JUNO-106

COUNTERMEASURE TO MEMORY BACK UP BATTERY

JUNO-106 MODIFICATION

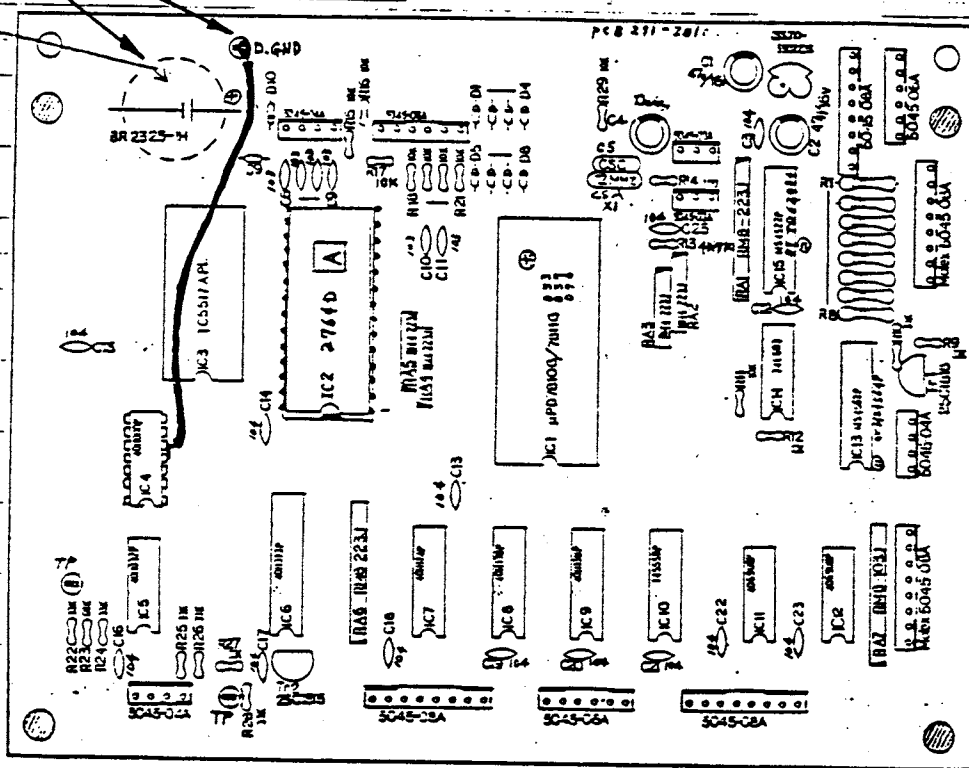
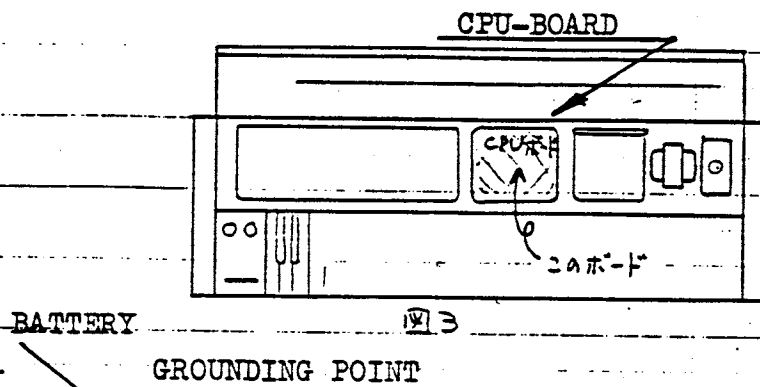
It was found that JUNO-106 is likely to break memory data in a short period as IC-4 40H000P on CPU BOARD draws a variance current ranging 250 micro ampere to zero.

The "floating" inputs (pins 4 and 5) of the unused section of IC-4 40H000P are the cause of this problem. The solution is that they should be connected to ground point by using a jumper wire. Please refer to the attached drawing.

STEP-1: Check whether the battery voltage is more than 2.8V or not.

STEP-2: If the battery voltage is less than 2.8V, please replace the battery with new one and then take above modification to CPU BOARD.

STEP-3: If the battery voltage is more than 2.8V, you do not need to replace the battery but need to take the modification.

NOTE: Firstly, connect a jumper wire to above ground point to prevent breaking IC from happening on, and then, connect the jumper wire to pins 4 and 5 of IC-4.

Pins 4 and 5 must be connected to grounding point by using a jumper wire.
